# Office Action Summary

09/521,367

KARASAWA, HITOSHI

Paul A Roberts

Figure 1

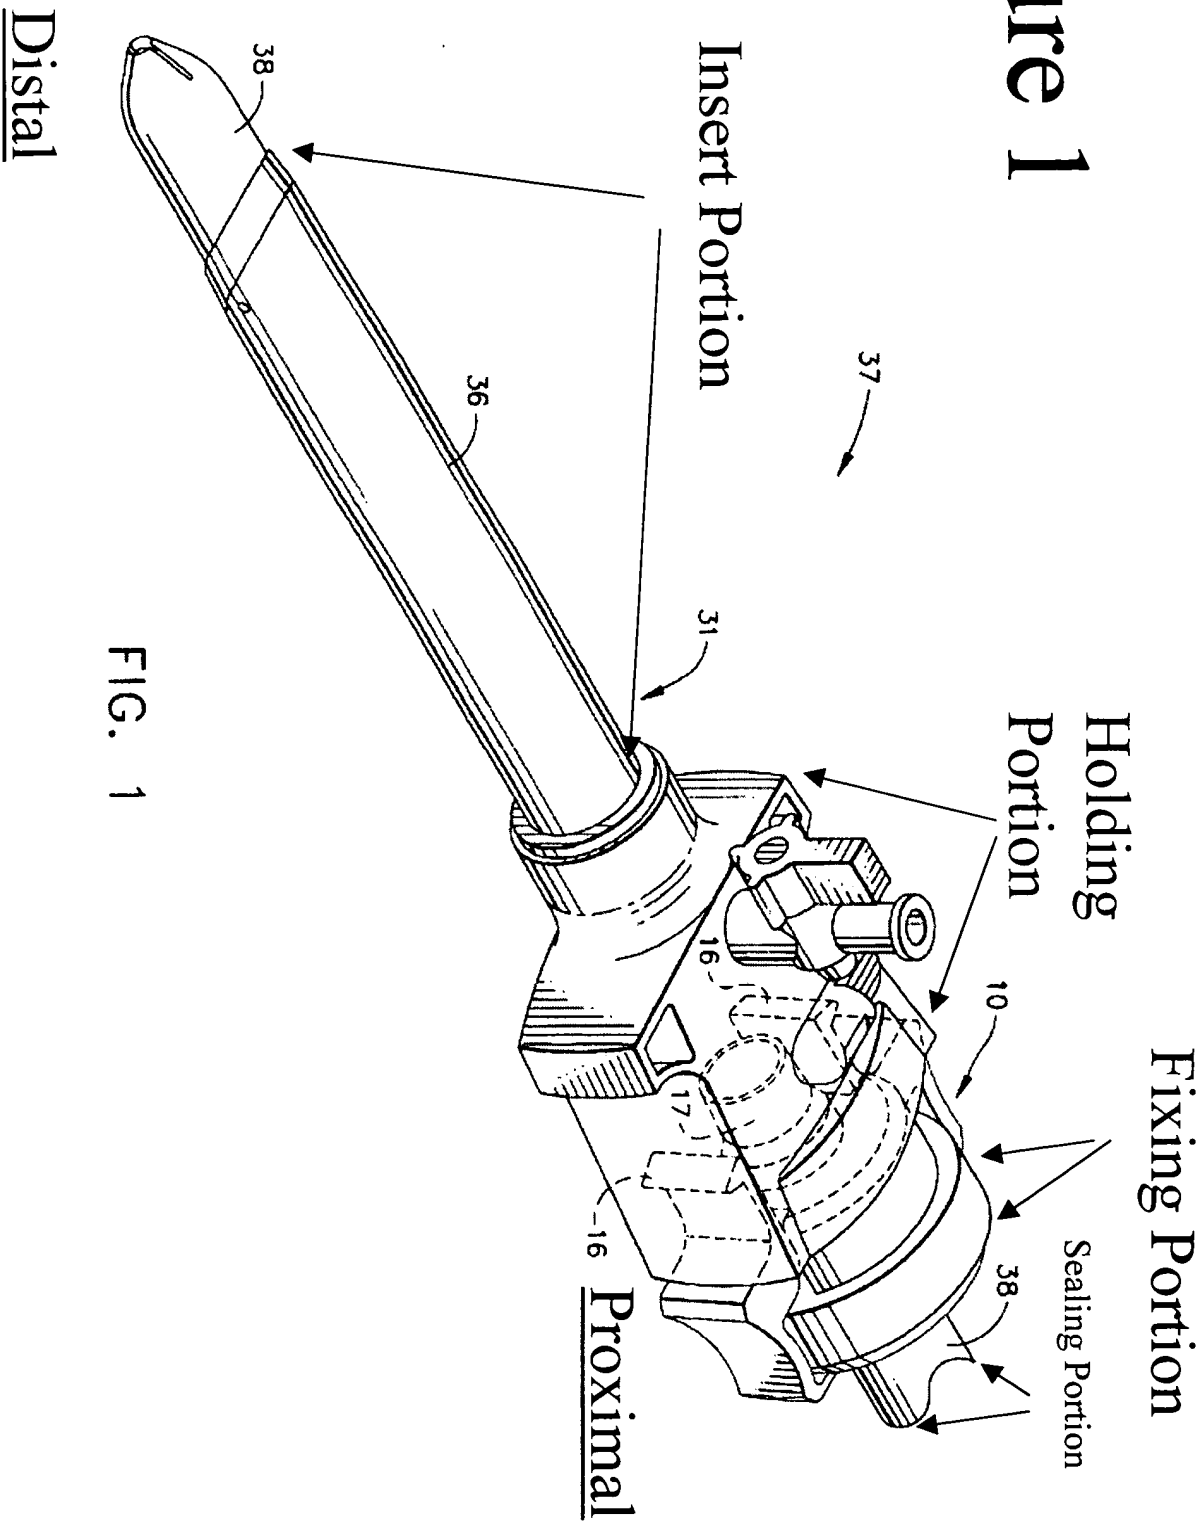
8. Claim 1-5,8,10,15,16,18, 19, 20, & 23 are rejected under 35 U.S.C. 102(b) as being anticipated by Kramer et al 5,792,113. Kramer teaches that a trocar can be assembled with:

- An insert portion capable of allowing a medical instrument to pass through it
- A holding portion equipped with an opening
- A removably mounted sealing member mounted to the holding portion
- A fixing member removably mounted to the sealing member

Please see the attached page figure 1. All of these parts are clearly labeled. The figure was taken from figure 1 in Kramer's patent 5,792,113.
